**Re: Wisconsin Power and Light Company – Columbia Energy Center
Response to July 26, 2011 EPA letter and Final Report Round 7 Dam
Assessment**

Columbia Energy Center Final Report Round 7 Dam Assessment Recommendations

Re: Technical Assessment
Response to EPA Comments of July 26, 2011
Columbia Energy Center – Pardeeville, WI

JOB	154
SHT.	FIGURE 1
DWG.	SITE PLAN

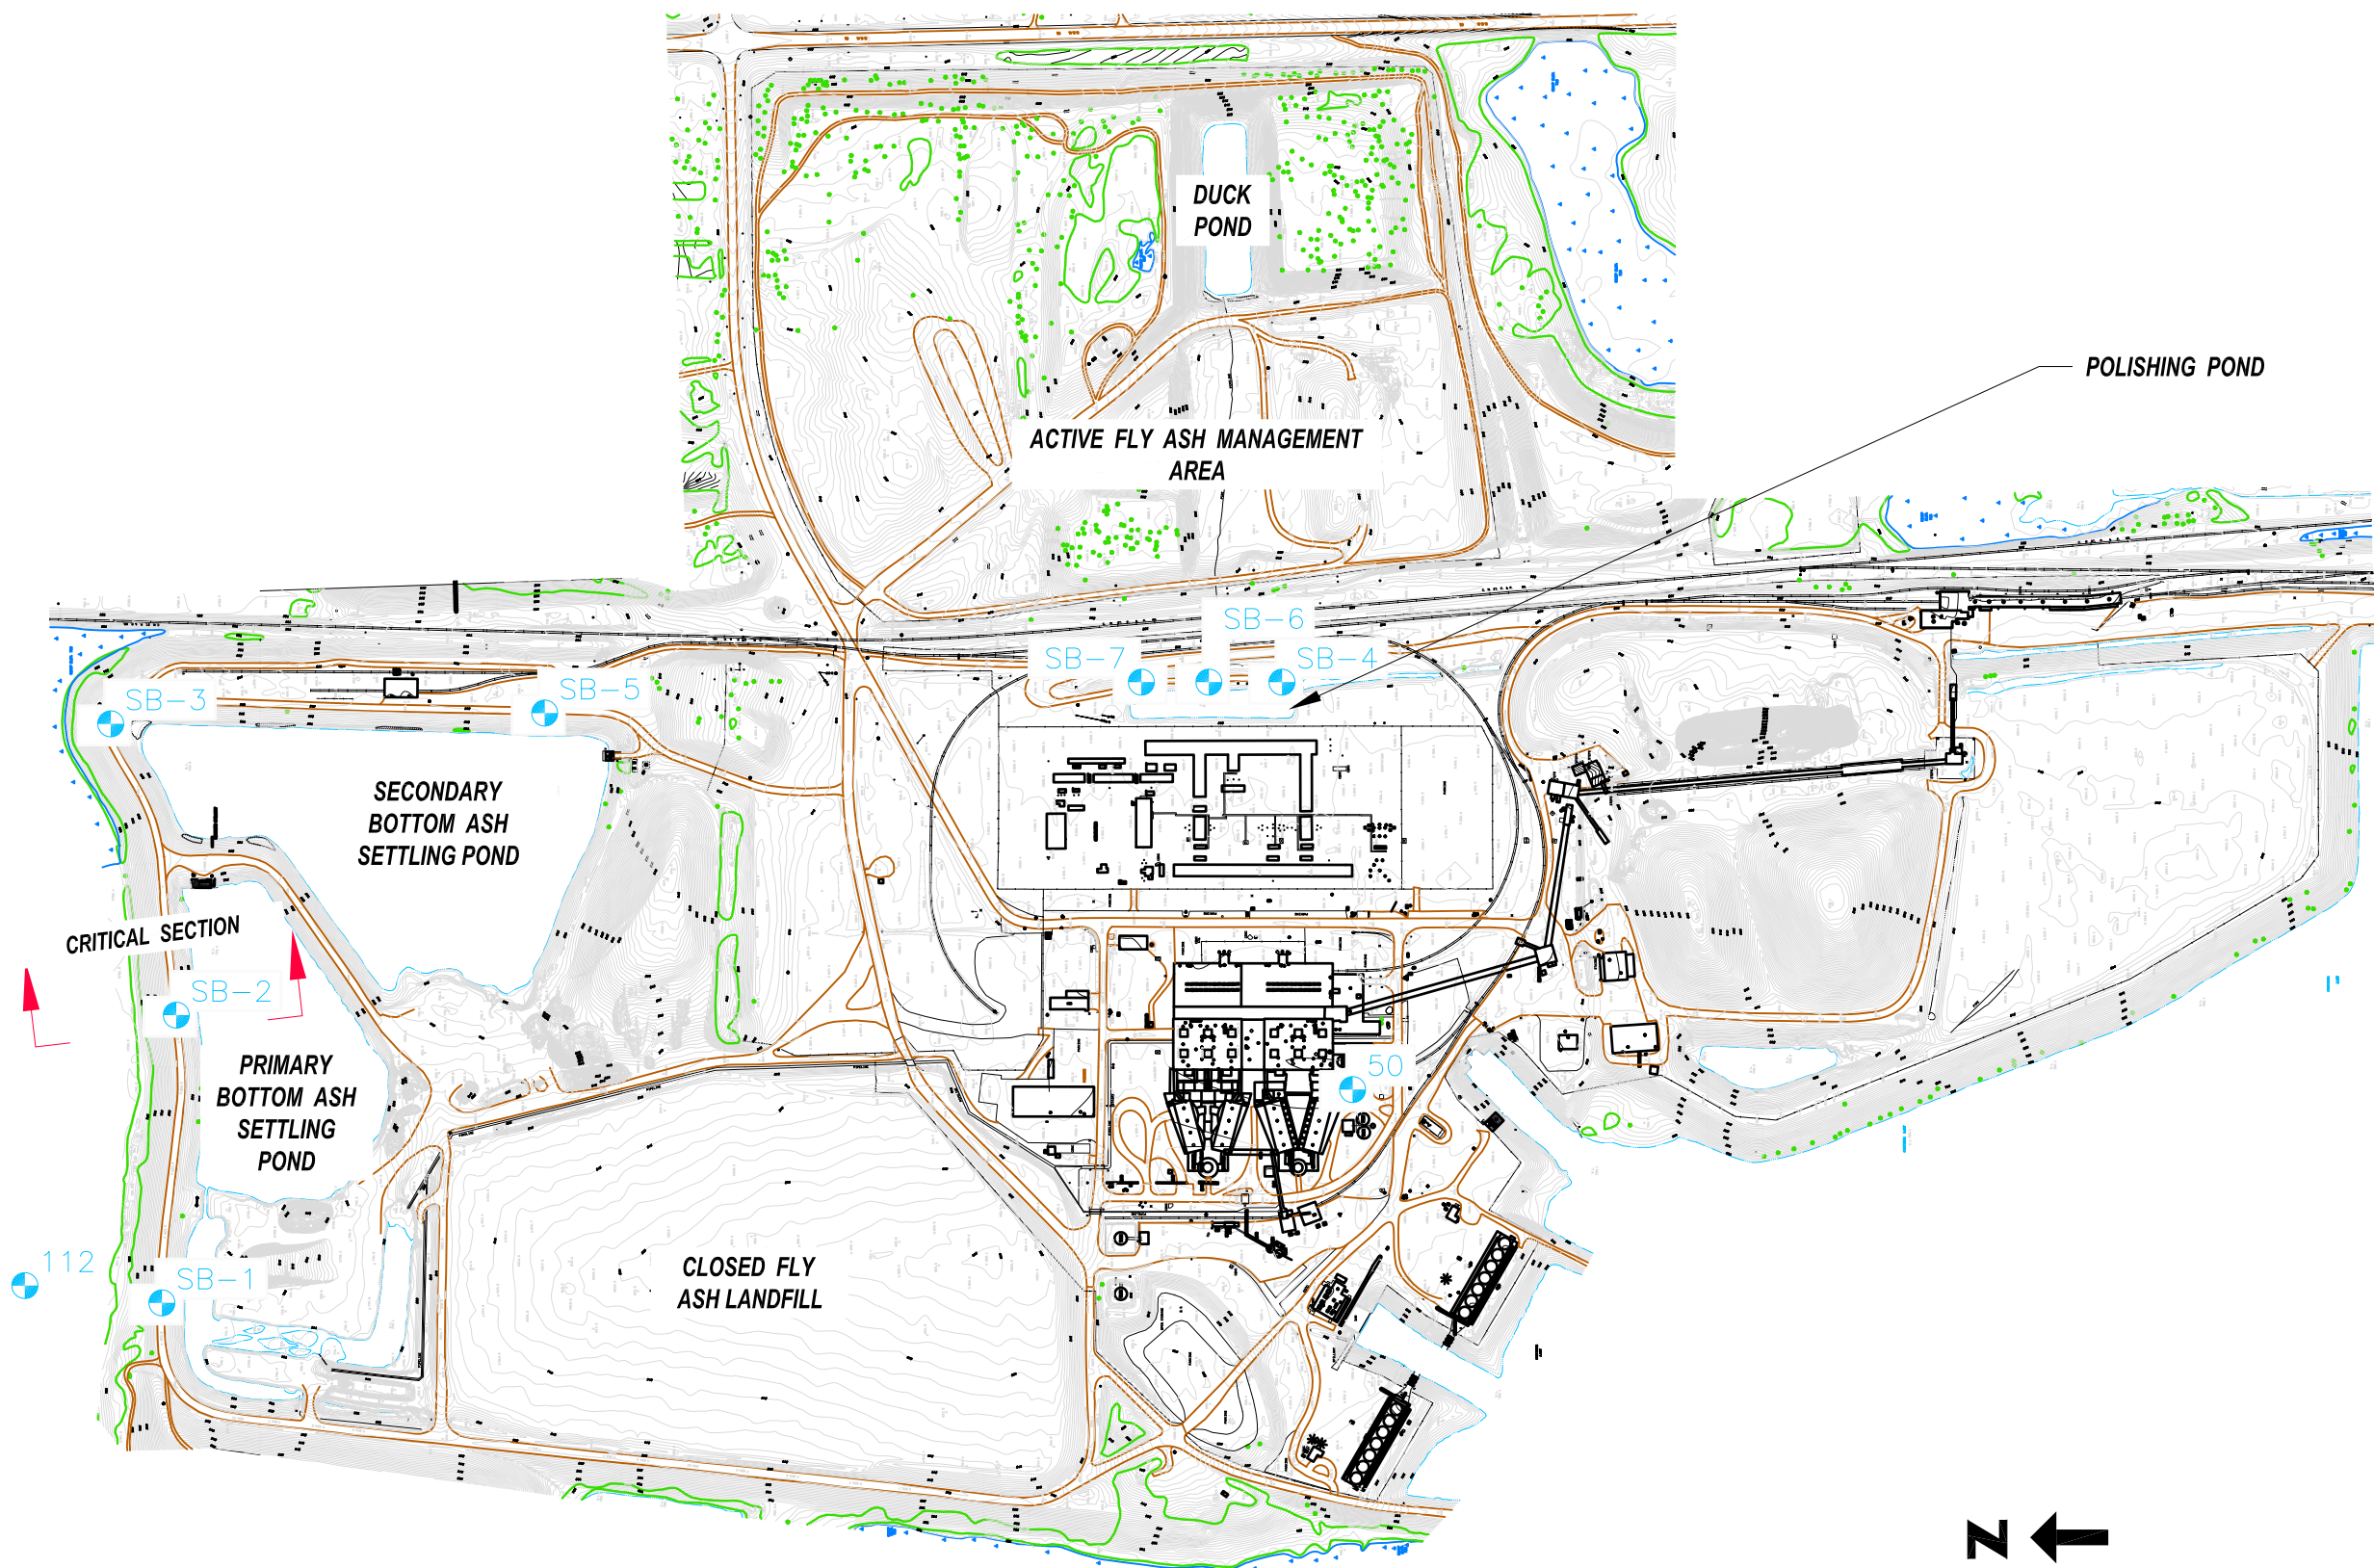
4. Confirm the soil and seepage parameters assumed in the stability analysis of the PAP and Secondary Ash Pond (SAP).

Soil borings and cone penetrometers were taken in June 2011 on the PAP, SAP and PP to confirm the materials of construction. The results were presented in a letter dated July 6, 2011, Attachment E. The results indicate that the internal friction angle of the embankment soil is equal to or greater than 35°. Since the analysis reported February 6, 2011 used a shear strength of 30°, the actual strength of the embankments is higher than report in February.

The geoprobe results indicate that the embankment materials are dense to very dense sand with a probable internal friction angle of 35 degrees or more. The investigation indicates that an analysis of the embankment stability using the June 2011 geoprobe results will exceed the Factor of Safeties reported in February 16, 2011 letter.
